City of Pittsburg
Planning Commission Agenda

AMENDED 6/20/25
06/24/2025

4. Consideration of a Resolution Granting a Use Permit and Design Review and adoption of an Initial Study Mitigated Negative Declaration and Mitigation Monitoring Reporting Program for the Pencco Iron Salts Manufacturing Facility, AP-23-0167 (UP, DR)

Clark & Associates
Environmental Consulting, Inc.

Figure 3: Project Site Plan

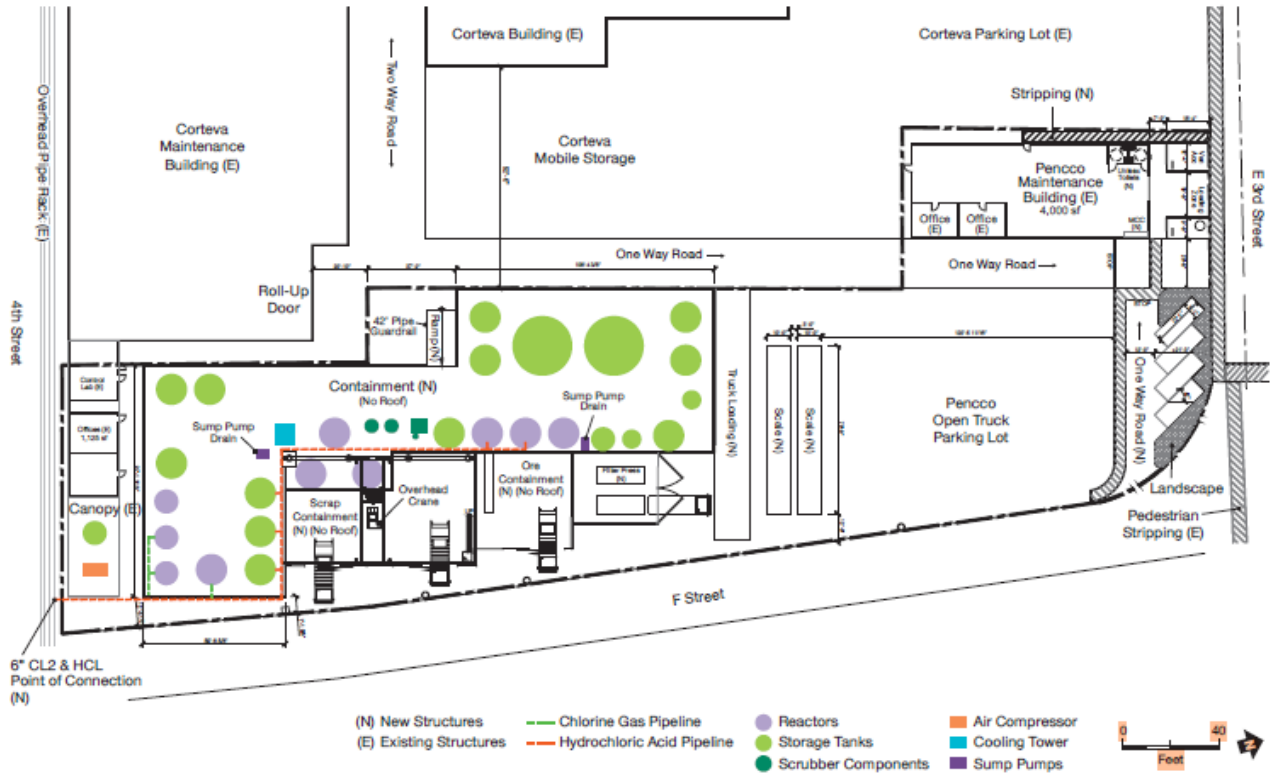
- 10 reactor tanks ranging from 10 to 13 feet in diameter and 16 to 20 feet in height (volume ranging from 10,000 to 24,000 gallons)
- 18 storage tanks ranging from 8 to 25 feet in diameter and 10 to 30 feet in height (volume ranging from 4,000 to 100,000 gallons)
- Two-stage air scrubber components including water and caustic scrubber, scrubber fan, and stack (20 feet tall) ranging from 2.7 to 6 feet in diameter
- Cooling Tower (12 feet in diameter and 10 feet in height)
- Filter press, ore and scrap containment areas, overhead crane, air compressor, and sump pump drains.

Process emissions would be emitted through one stack for the entire facility, which would be driven through the stack by the air scrubber fan. The fan would pull fugitive emissions from the processes into a packed-bed column scrubber permitted by the Bay Area Air Quality Management District (BAAQMD).

Figure 4: State Water Resources Control Board Summary of Measurements At Well 408B1

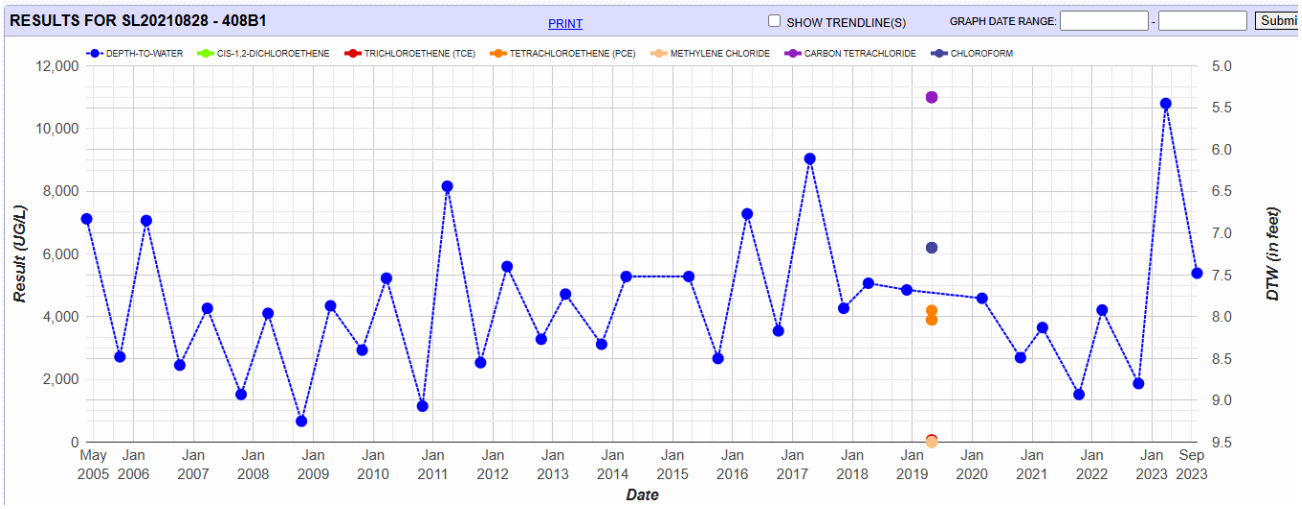
The industrial complex has historically been used for production of chlorine, sodium hydroxide, hydrogen, and chlorinated solvents such as carbon tetrachloride and tetrachlorethylene (PCE). The site continues to manufacture latex, agricultural chemicals, fumigants, fungicides, and hydrochloric acid. Groundwater monitoring data from the wells closest to the Project site (408B1 and 424C) indicate the presence of multiple hazardous contaminants, including carcinogens such as cis-1,2-dichloroethene, trichloroethene (TCE), PCE, methylene chloride, carbon tetrachloride, chloroform, vinyl chloride, and benzene.

Health Risk Assessment Assumptions

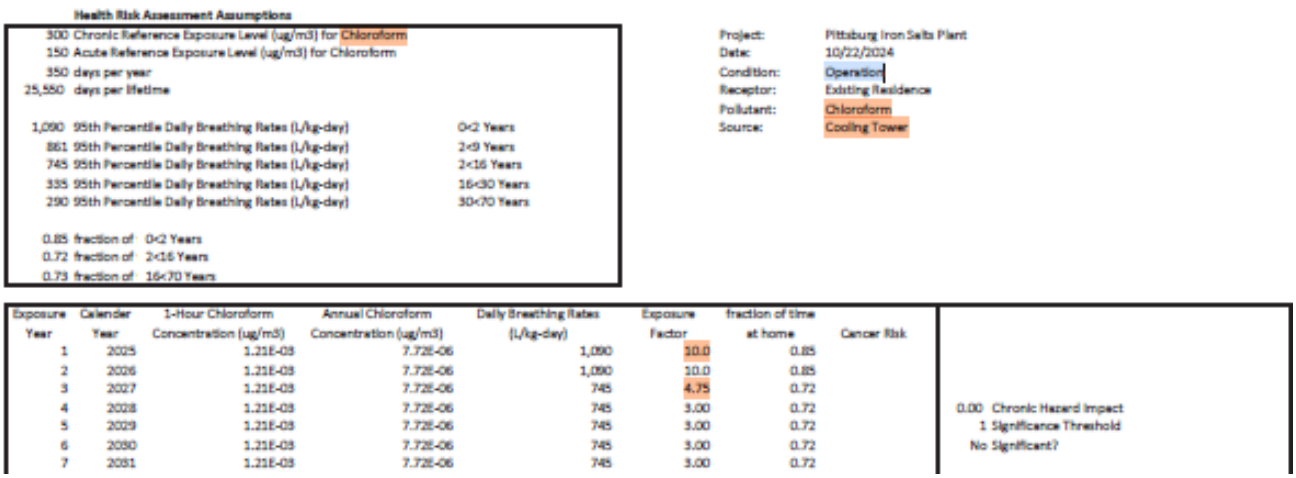
1. $$Dose_{air} = C_{air} * \{BR/BW\} * A * EF * 10^{-6}$$

2. $$Risk_{inh} = Dose_{air} * CPF * ASF * ED/AT$$

300	Chronic Reference Exposure Level (ug/m3) for Chloroform	
150	Acute Reference Exposure Level (ug/m3) for Chloroform	
350	days per year	
25,550	days per lifetime	
1,090	95th Percentile Daily Breathing Rates (L/kg-day)	0<2 Years
861	95th Percentile Daily Breathing Rates (L/kg-day)	2<9 Years
745	95th Percentile Daily Breathing Rates (L/kg-day)	2<16 Years
335	95th Percentile Daily Breathing Rates (L/kg-day)	16<30 Years
290	95th Percentile Daily Breathing Rates (L/kg-day)	30<70 Years
0.85	fraction of	0<2 Years
0.72	fraction of	2<16 Years
0.73	fraction of	16<70 Years
